QUALITY ASSURANCE -- NON-CONFORMANCE REPORT

Location: Changxing Island, Shanghai, P.R. China **Report No:** NCR-000304
Prime Contractor: American Bridge/Fluor Enterprises, a JV **Date:** 10-Jun-2009
Submitting Contractor: Zhenhua Port Machinery Company, Ltd (ZPMC), Changxing Island **NCR #:** ZPMC-0278

Reference Description: Missed MT Indications by QC, Segment 4BW

Job Name: SAS Superstructure

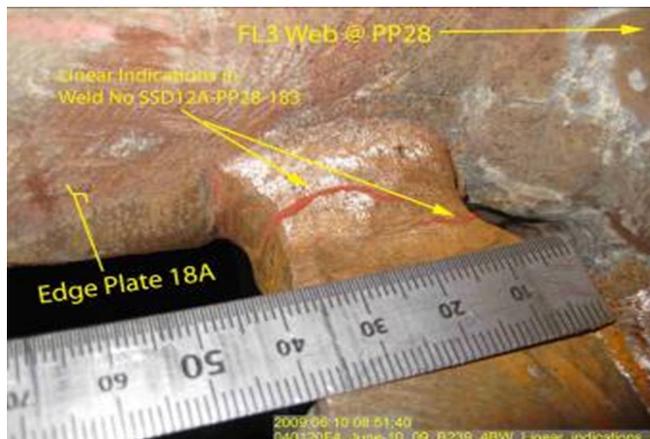
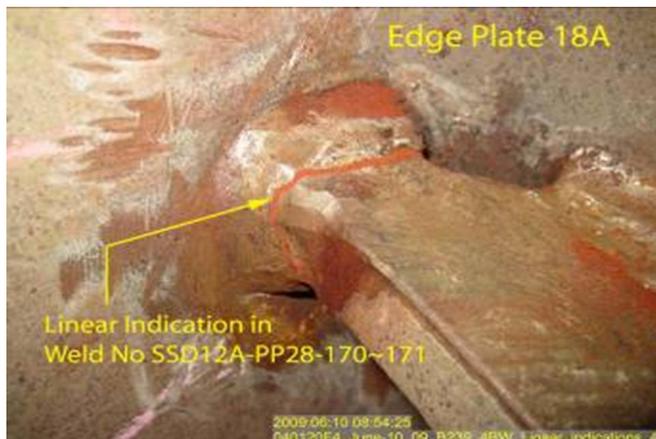
During random verification magnetic particle testing (MT) of the FL3 floor beam horizontal stiffener attachment welds (to Edge Plate 18A), Caltrans Quality Assurance (QA) Inspector discovered a total of four (4) longitudinal linear indications. These indications ranging from 25 to 35mm in length were observed in welds: SSD12A-PP28-170, 171, 175, 176, 183 and SSD10A-PP26-180. These welds have been previously tested and accepted by ZPMC Quality Control (QC) MT and UT technicians.

AWS D1.5 (02) Section 6.26.2 – “Welds that are subject to MT in addition to visual inspection shall have no cracks.”

Reference Description: Missed MT Indications by QC, Segment 4BW

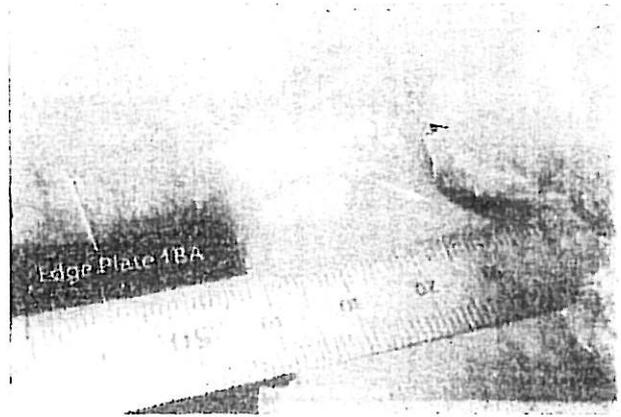
During random verification magnetic particle testing (MT) of the FL3 floor beam horizontal stiffener attachment welds (to Edge Plate 18A), Caltrans Quality Assurance (QA) Inspector discovered a total of four (4) longitudinal linear indications. These indications ranging from 25 to 35mm in length were observed in welds: SSD12A-PP28-170, 171, 175, 176, 183 and SSD10A-PP26-180. These welds have been previously tested and accepted by ZPMC Quality Control (QC) MT and UT technicians.

AWS D1.5 (02) Section 6.2.6.2 – “Welds that are subject to MT in addition to visual inspection shall have no cracks.”

Draft of Welding Discontinuity:

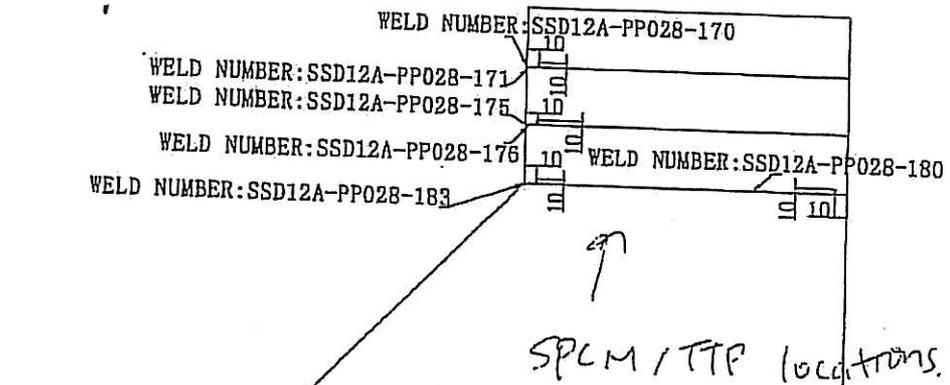
One transverse crack was found by use of MT on each weld(SSD12A-PP028-180、SSD12A-PP028-170、SSD12A-PP028-171、SSD12A-PP028-175、SSD12A-PP028-176、SSD12A-PP028-183). 10mm in length on each weld.

1. 火焰加热时, 水汽没有完全的去掉或者这个区域预热不够;
1. Moisture wasn't completely removed during drying operation (preheating) or the area wasn't preheated sufficiently.

1. Remove the crack by means of grinding.
2. Prepare excavation according to the approved repair WPS.
3. Verify with VT and MT repair areas are crack free.
4. Preheat and weld according to the approved repair WPS.
5. Preheat prior to welding to a minimum temperature of 100°C
6. The preheat area shall be a minimum of 150mm in all directions around the repair area
7. Grind the repaired area flush with base metal or the adjacent weld.
8. Perform VT and MT of the repair areas.

shall allow preheat requirement according to the Fcrl specification

- Additional NDT requirement as stated in the special provisions § 1.59 Inspection and testing note 3.

Draft of Welding Discontinuity:

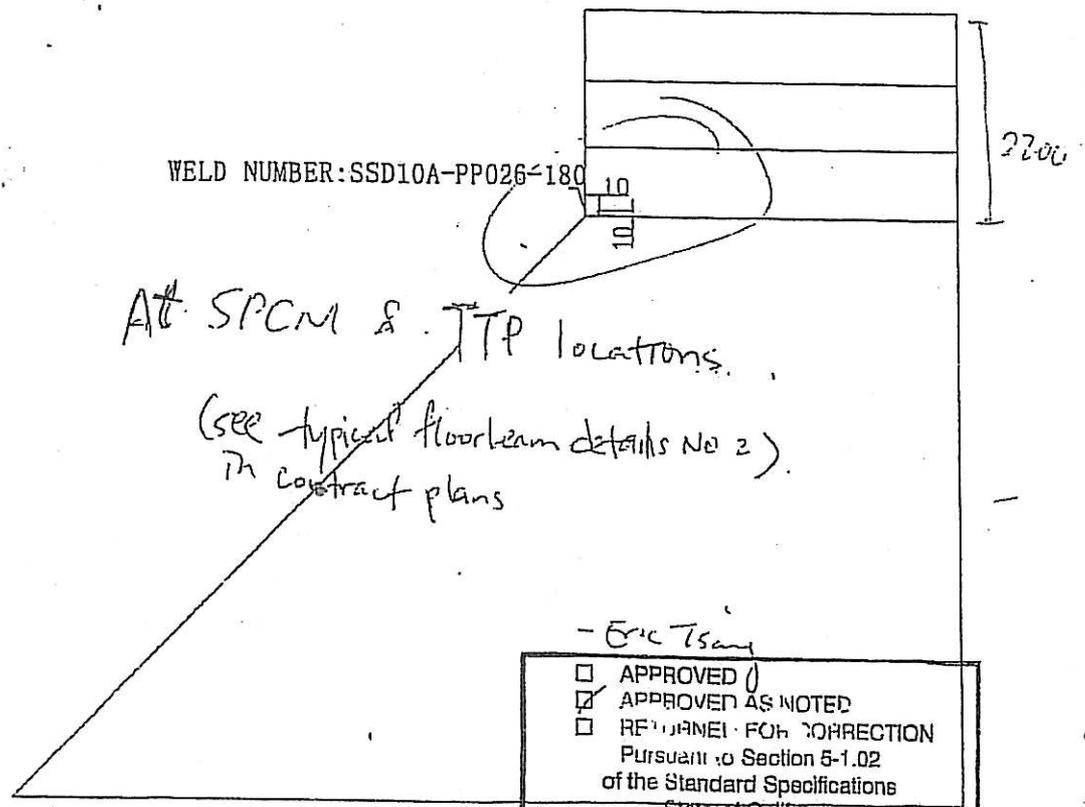
One transverse crack was found by use of MT on weld (SSD10A-PP026-180). L=10mm.

- 1. 火焰加热时, 水汽没有完全的去掉或者这个区域预热不够;
- 1. Moisture wasn't completely removed during drying operation (preheating) or the area wasn't preheated sufficiently.

- 1. Remove the crack by means of grinding.
- 2. Prepare excavation according to the approved repair WPS.
- 3. Verify with VT and MT repair areas are crack free.
- 4. Preheat and weld according to the approved repair WPS.
- 5. Preheat prior to welding to a minimum temperature of 100°C
- 6. The preheat area shall be a minimum of 150mm in all directions around the repair area
- 7. Grind the repaired area flush with base metal or the adjacent weld.
- 8. Perform VT and MT of the repair areas.

- Additional NDT requirement as stated in special provisions § 1.59-Inspection and Testing - Note 3.

*MT prior to re-welding
temperature according to
FCM repair procedure*
